Key Largo Wastewater Treatment District Board of Commissioners Meeting Agenda Item Summary

KLWTD Power Conditioning Project Change Order #1 Option 2B

**SECTION 00950
CHANGE ORDER FORM**

To: Peter Rosasco, General Manager
From: Lexi Connor, E.I., Weiler Engineering
Date: May 6, 2025
Re: KLWTD Power Conditioning & Electrical Upgrades Project

PLAN PER CONTRACT

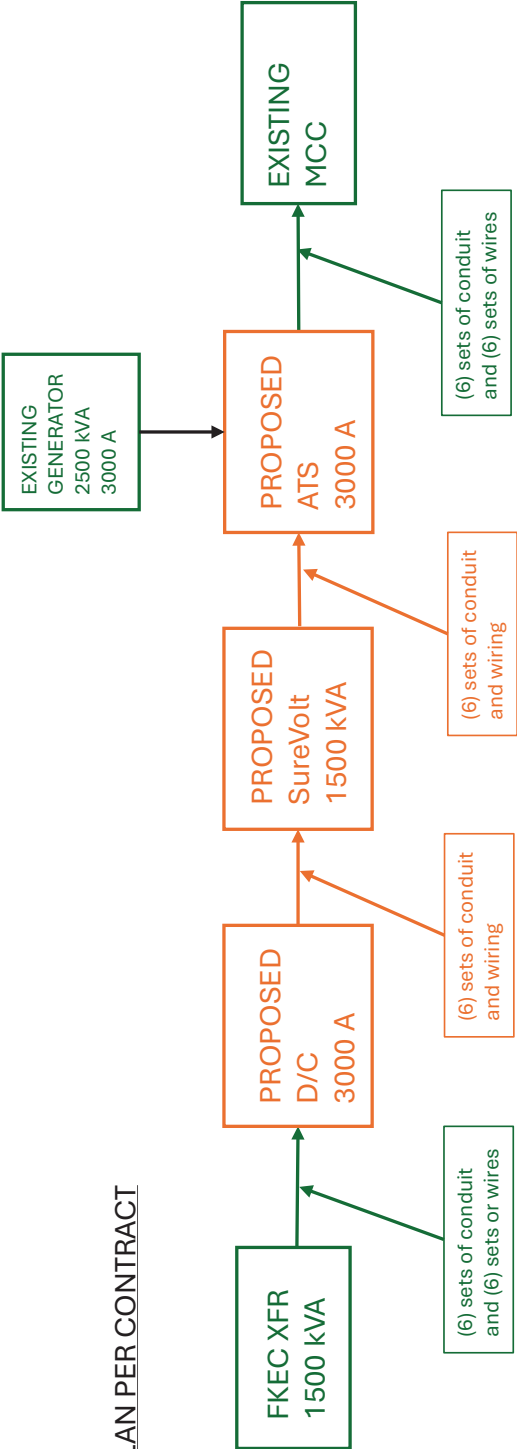
To help illustrate the differences between each option, the attached diagrams show the existing setup, planned contract upgrades, and the proposed change order options (Option 1, 2A, and 2B).

OPTION #1
TOTAL: \$277,454.87

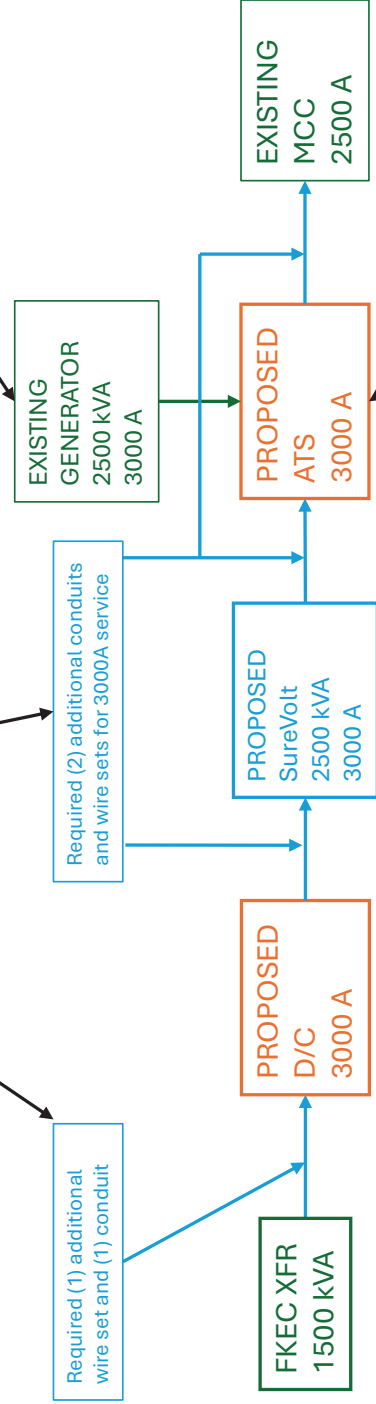
- Upgrade service to **3000A rated SureVolt (upsized to 2500 kVA), and necessary conduits/wiring.**
- Provides the required service capacity for EQ Tank/Headworks and future expansions.
- **Portable generator connection would still require hardwiring into ATS or MCC main breaker during emergencies.**

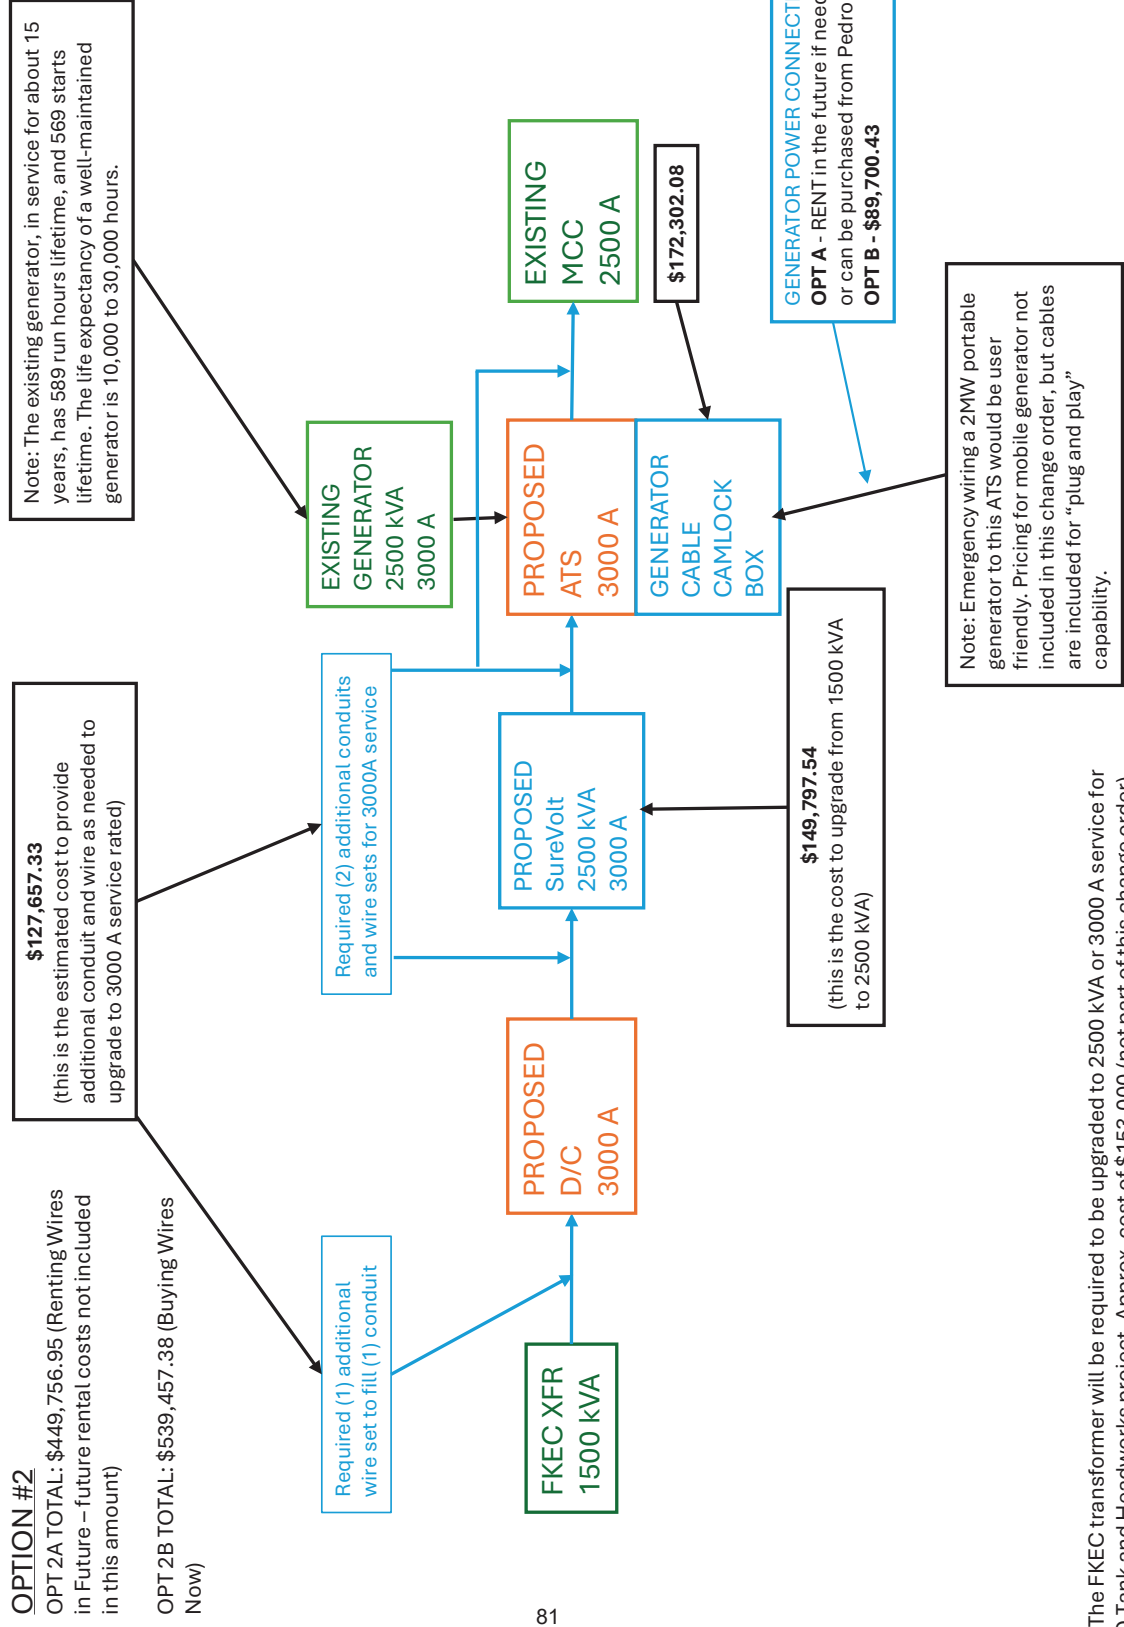
\$127,657.33
(this is the estimated cost to provide additional conduit and wire as needed to upgrade to 3000 A service rated)

\$149,797.54
(this is the cost to upgrade from 1500 kVA to 2500 kVA)

Note: The FKEC transformer will be required to be upgraded to 2500 kVA or 3000 A service for the EQ Tank and Headworks project. Approx. cost of \$153,000 (not part of this change order)
